Access Compliance Report

Public Rights-of-Way

Intersection ID: 52688	Main Street: CITY_PARK_DR	Cross Street: ARBOR_LOOP_DR	Location: NW
ADA ID: A823AA790909	Ramp Type: Perp	Initial Pass/Fail: Fail	Overall Compliance: No
		Severity Score: 12.5

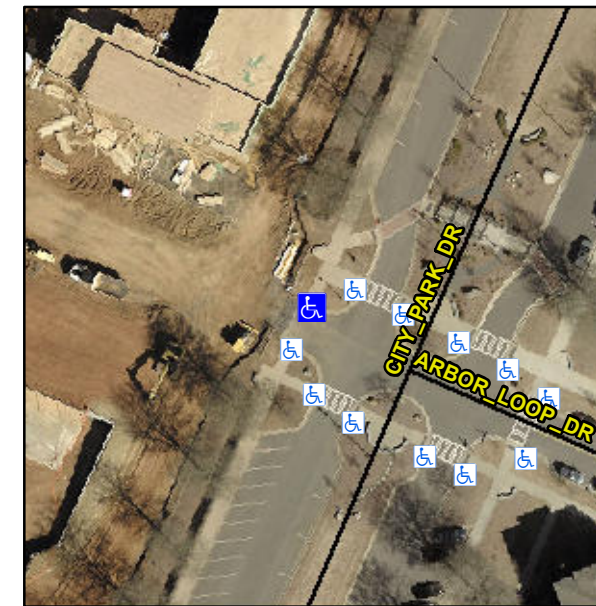
R304.2.2

Compliance	Description	Data	Compliance	Description	Data
N/A	Ramp Length (in)	166.0	No	Ramp Slope (%)	8.6
Yes	Ramp Width (in)	70.0	Yes	Ramp XSlope (%)	0.8
N/A	Flare Type LT	N/A	N/A	Flare Type RT	N/A
N/A	Flare Slope LT (%)	N/A	N/A	Flare Slope RT (%)	N/A
N/A	Flare Traversable LT?	N/A	N/A	Flare Traversable RT?	N/A
N/A	Landing Length (in)	N/A	N/A	DWS Provided?	N/A
N/A	Landing Width (in)	N/A	N/A	DWS Contrast?	N/A
N/A	Landing Slope (%)	N/A	N/A	DWS Length (in)	N/A
N/A	Landing X Slope (%)	N/A	N/A	DWS Full Width?	N/A
N/A	Landing Curb? (Y/N)	N/A	N/A	DWS Offset (in)	N/A
N/A	Shared Landing?	N/A			
N/A	Gutter Ponding?	N/A	N/A	Gutter Slope (%)	N/A
N/A	Gutter Lip Ht (in)	N/A	N/A	Gutter X Slope (%)	N/A
N/A	Painted X Walk1?	No	N/A	Painted X Walk2?	N/A
	X Walk 1 Direction	To SW		X Walk 2 Direction	N/A
N/A	X Walk 1 Width (in)	N/A	N/A	X Walk 2 Width (in)	N/A
	X Walk 1 Slope (%)	3.8		X Walk 2 Slope (%)	N/A
	X Walk 1 X Slope (%)	2.3		X Walk 2 X Slope (%)	N/A

Remove & Replace Entire Ramp.
